May 5, 2000

Re: Amendment Request to Process an Alternate Feed Material from W.R. Grace at the
White Mesa Uranium Mill
Source Material License SUA-1358

Tailings Capacity Evaluation

White Mesa Uranium Mill
Blanding, Utah

SECTION A-A'
(See Figure III-1)

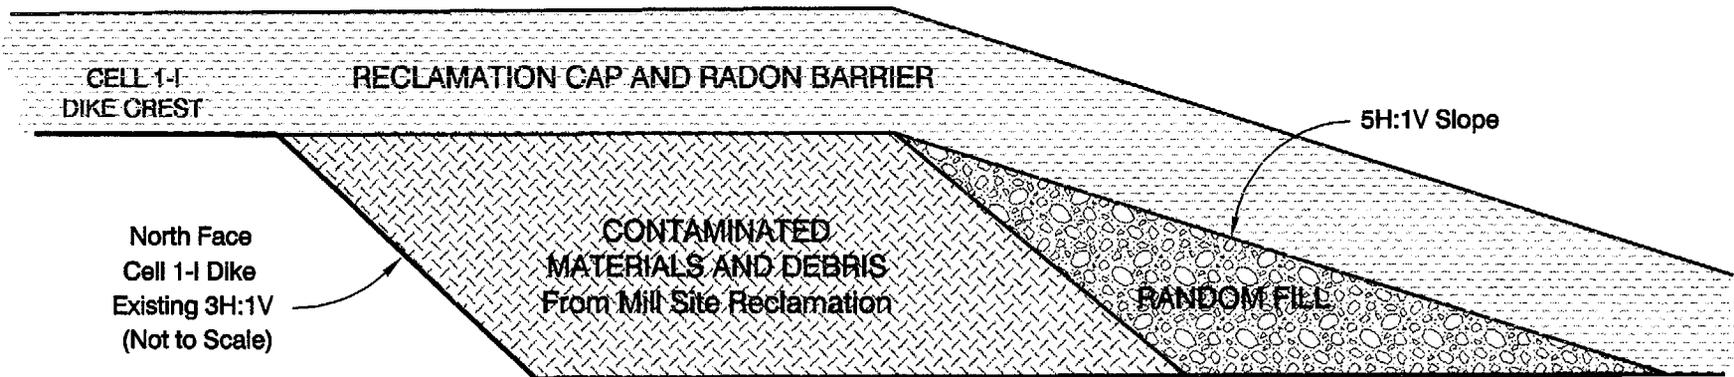
NRC requested that IUSA clarify that sufficient capacity is available in the existing tailings management system for the disposal of the tailings from the W.R. Grace material and the other approved and pending materials, plus the estimated quantity from the eventual reclamation of the tailings system and the mill site.

In order to provide for sufficient tailings capacity, IUSA proposes a modification to the implementation of the Reclamation Plan to allow for storage, in the Cell 1-I impoundment area, of an estimated 325,000 tons of relatively dry contaminated material generated during the final reclamation of the facility. The use of Cell 1-I impoundment for specific reclamation material would have no significant environmental impact because the material would be placed relatively dry and immediately covered with the final reclamation cap. The reclamation materials would be placed along the upstream face of the dike between Cell 1-I and Cell 2, extending along the entire length of the dike. The total additional area would be approximately 9 acres. The tailings area cap, including random fill, clay cap and rock armour would extend from the Cell 2 area as a continuous layer over the additional material.

The second alternative is to modify the Reclamation Plan to allow for placement of approximately 280,000 yd³ of material from the Mill site cleanup, along the north slope of the Cell 2 dike, within a portion of the current Cell 1-I. The current Reclamation Plan specifies that all of the contaminated materials from Cell 1-I are to be removed from the cell upon final site reclamation, and the impoundment is to act as a sedimentation basin with an outlet to the canyon on the west side of the site. A scenario, which does not deviate from the general concepts of the existing Reclamation Plan, is to use a portion of the existing Cell 1-I excavation to store low moisture content material from the mill site, windblown areas and the mill debris, upon final decommissioning of the site

The remaining contaminated materials and debris from the Mill area reclamation would be placed along the upstream face of the dike between Cell 1-I and Cell 2, extending along the entire length of the dike. See Figure IV-1. The estimated volume of this material, 280,000 yd³, would cover an area approximately 160 feet wide along the 2,400 foot length of the dike. The total additional area would be approximately 9 acres. The width of the additional contaminated material would vary depending on the final volume of cleanup materials, and the concept would give the added advantage of having additional storage, if needed, in the remaining area of the Cell. The tailings area cap, including random fill, clay cap and rock armour would extend from the Cell 2 area as a continuous layer over the additional material. While the material placed in the Cell 1-I area will not have a bottom liner, the fact that the material is placed relatively dry (estimated to be less than 10% moisture content) and quickly covered with an engineered cap, will prevent any natural precipitation from moving through the material. This will eliminate the potential for migration of contaminants from this area. The current reclamation plan specifies that the Cell 1-I impoundment area is to act as a sedimentation basin with an outfall to the canyon on the west side of the site. This concept will still be preserved with approximately 80% of the Cell 1-I area still available for the sedimentation basin. The final location of the outfall channel will be adjusted based on the volume and area of material stored in Cell 1-I.
